GUAM POWER AUTHORITY

AMENDMENT NO.: XIII

INVITATION FOR MULTI-STEP BID NO.: GPA-012-23

RENEWABLE ENERGY RESOURCE ACQUISITION PHASE IV

1. **Clarification #1**

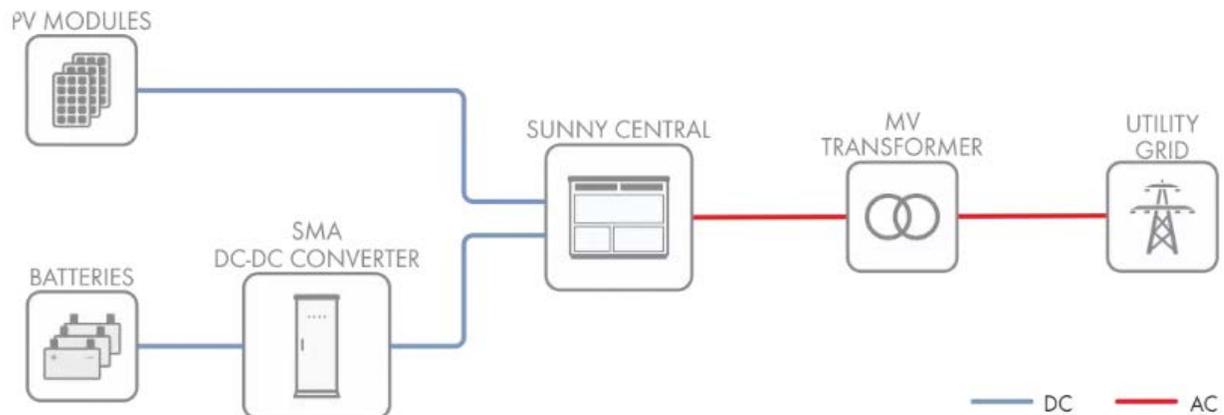
In the utility environment, there are many operating cases of the utility-scale DC-coupled configuration. Typical and commercially available configuration is PV Modules and BESS Batteries with DC-DC converter connected to **PV Inverter**, PV Inverter connected to MV Transformer, then connected to Utility Grid. SMA is one of the leading manufacturers in the PV-BESS Inverter market and below is its DC-coupling system configuration. Also, other major manufacturers' DC-coupled configurations are similar. i.e. PV Inverter is used for DC-coupled configurations.

Unfortunately, we didn't see the utility-scale DC-coupled configuration which PV Modules DC-coupled to the BESS Batteries, the BESS Batteries connected to the PCS (instead of PV Inverter), and then connected to the grid. Between PV Modules and BESS Batteries, there should be specific equipment such as Charge Controller for DC-coupling and controls of PV-BESS.

1) Please provide its specification, manufacturer, and model number for Bidder's information. Bidder's concern is that specific equipment for DC-coupling may not be compatible with other PV-BESS equipment which will be provided by major manufacturers in the utility market.

2) Also, please provide referenced PV-BESS projects information which adopted and operating the utility-scale DC-coupled configuration that GPA's consultant is referring to.

3) Dully noted that Bidders shall be responsible for the design of the system. Therefore, please confirm that the Bidder will NOT be disqualified when the proposed PV-BESS system configuration is AC-coupled that the Bidder believes it will provide more Resiliency, Functionality, Versatility, and Flexibility to GPA grid system.

GPA affirms its previous answer issued in Amendment XII, specifically:

"GPA has confirmed the utility-scale DC-coupled configuration with its consultant and is therefore upholding the requirement to DC-couple 50% of the resource to the energy storage system.

However, Bidders shall be responsible for the design of the system."

Bidders shall be responsible for the design of the system that meets the requirements specified in the bid. GPA cannot confirm that a Bidder's proposal will not be disqualified if the bid requirements are not met.
